Product Change Notice (PCN)

PCN Number: **PCN-0450975R-01**

Product(s) Affected: SJ1-3523N, SJ1-3524N, SJ1-3525N

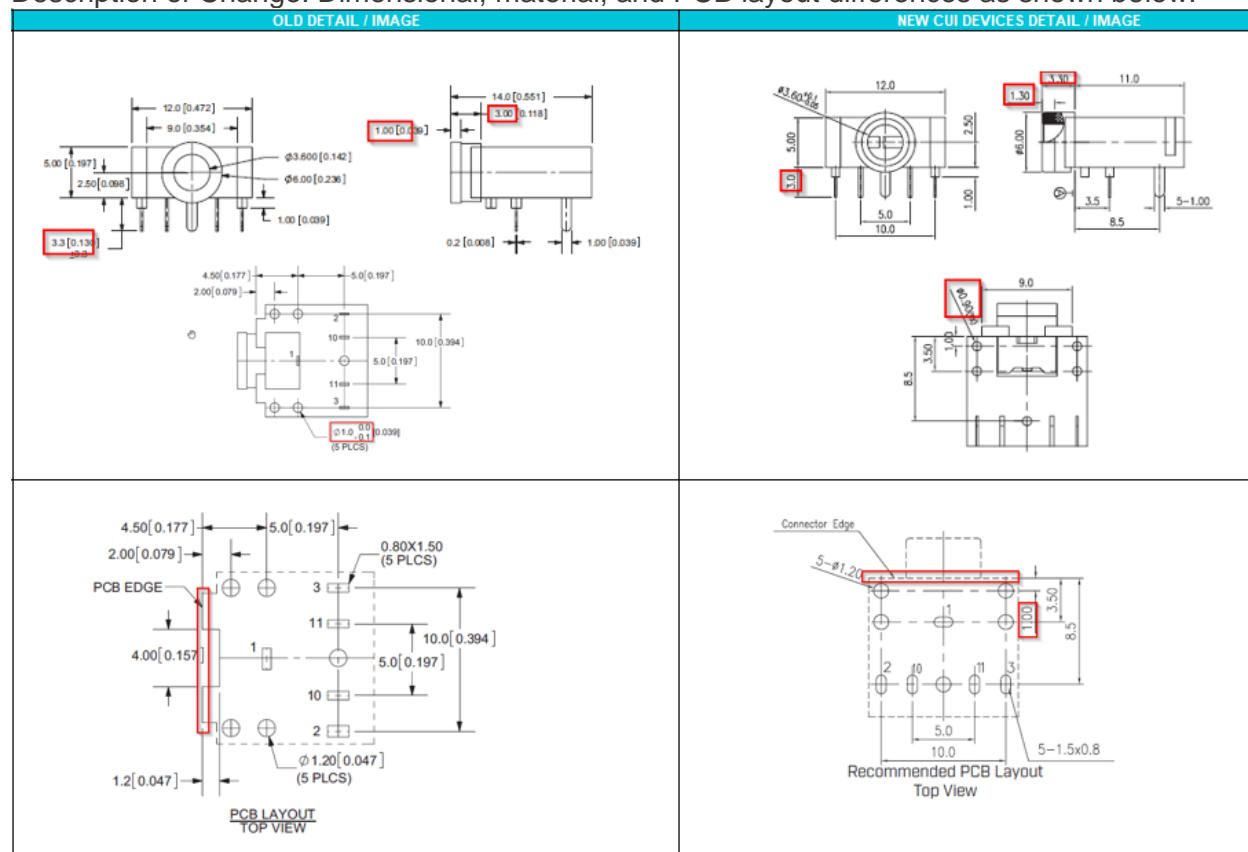
Description of Change: Dimensional, material, and PCB layout differences as shown below:

MATERIAL	PLATING
terminal 1	copper alloy	silver
terminal 2	copper alloy	silver
terminal 3	copper alloy	silver
terminal 10	brass	silver
terminal 11	brass	silver
bushing	brass	nickel
plastic	PBT

DESCRIPTION	MATERIAL	PLATING/COLOR
terminal 1	copper alloy t=0.20	silver over nickel
terminal 2	stainless steel t=0.20	silver over nickel
terminal 3	stainless steel t=0.20	silver over nickel
terminal 10	brass t=0.40	silver over nickel
terminal 11	brass t=0.40	silver over nickel
bushing	brass	nickel
housing	PBT (UL94V-0)	black
